**TECHNICAL BULLETIN: 12-09**

**DATE:** September 26, 2012

**SUBJECT:** Cassette Height Adjustment on HCDU/SCDU for Canada

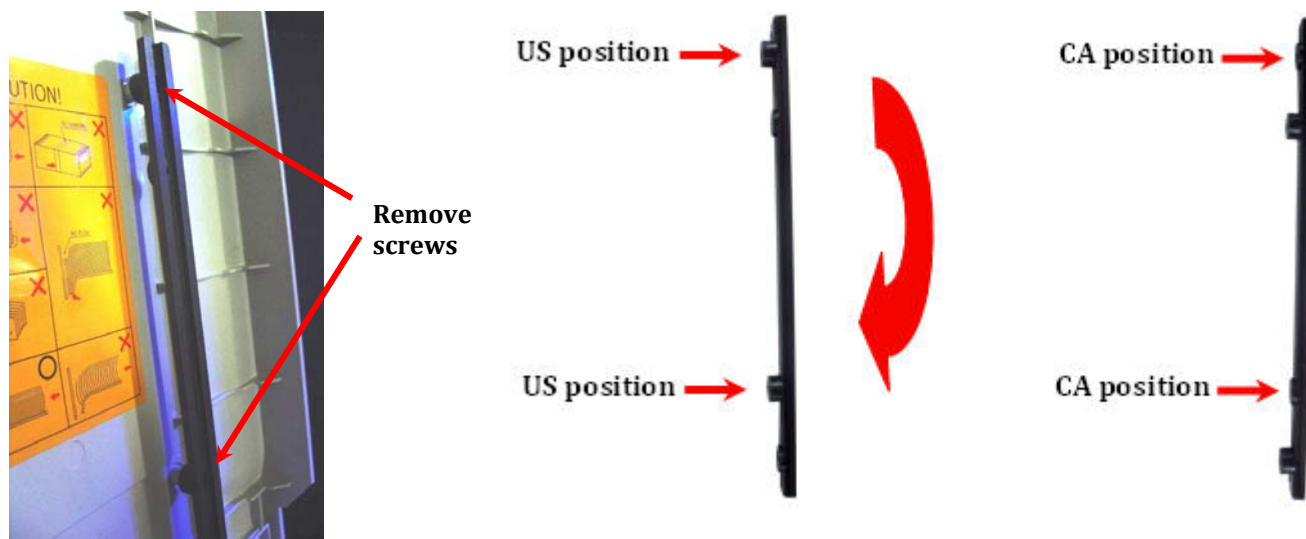
HCDU/SCDU dispensers (as may be found in the Triton Traverse) require a height adjustment of the cassette(s) for Canadian currency. If an HCDU or SCDU cassette is found still set to US configuration, the adjustment can be made by simply removing the height rails from the cassette lid, rotating them, and reattaching with the same screws.

Traverse units shipped to Canada should be configured for Canadian currency prior to shipment from Triton.
